### REPAIR AND OVERHAUL INSTRUCTIONS

# CONTROL PEDESTAL REPAIR SCHEME AT THE PRIMING PUMP MOUNTING FLANGE

Figure 1

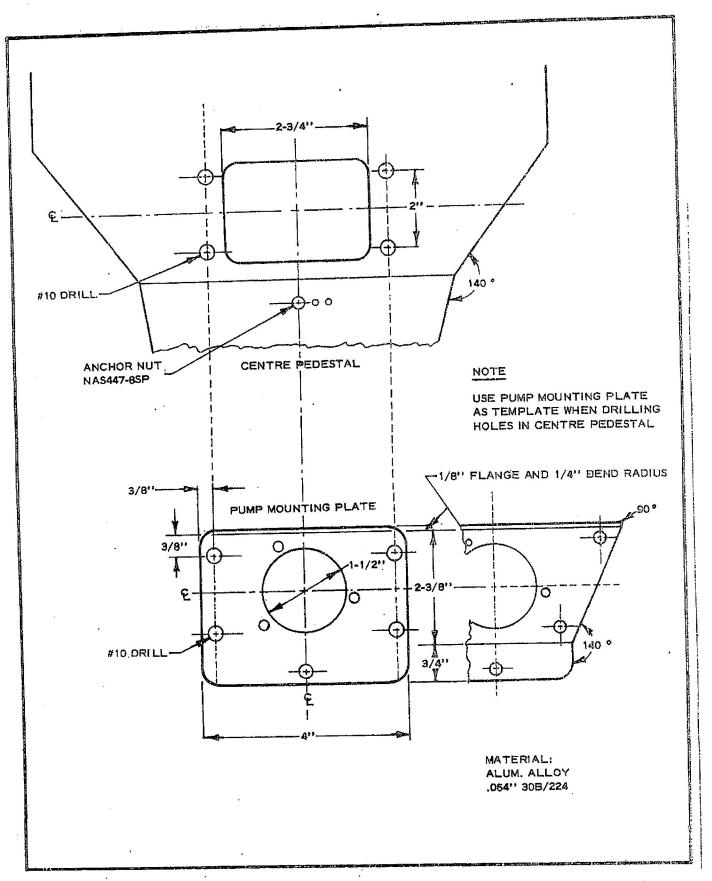
As a result of flexing of the control pedestal skin during priming pump operation cracks may develope in this area.

- (b) Cut hole in pedestal in accordance with Figures 1 and 3.
- (c) Manufacture mounting plate and doubler plate in accordance with Figures 1 and 2.
- (d) Using mounting plate and doubler as guide, drill five holes, in centre pedestal. (using #10 drill)
- (e) Locate priming pump on mounting plate by drilling 3 holes in mounting plate using pump as guide. Ensure OFF position on pump will be vertical when installed on aircraft.
- (f) Rivet doubler plate to centre pedestal with 8 rivets 28/5320-00-117-6938. (Utilizing the same 8 rivets to attach 4 anchor nuts Part NAS447-8SP to the bottom surface of doubler plate as per Figure 3).
- (g) Affix pump to mounting plate using existing screws and nuts.
- (h) Mount the pump on centre pedestal using 5 screws AN526-832R8.
- (j) Complete pipe connections under centre pedestal and check for leaks;
- (k) Paint mounting plate to match pedestal.
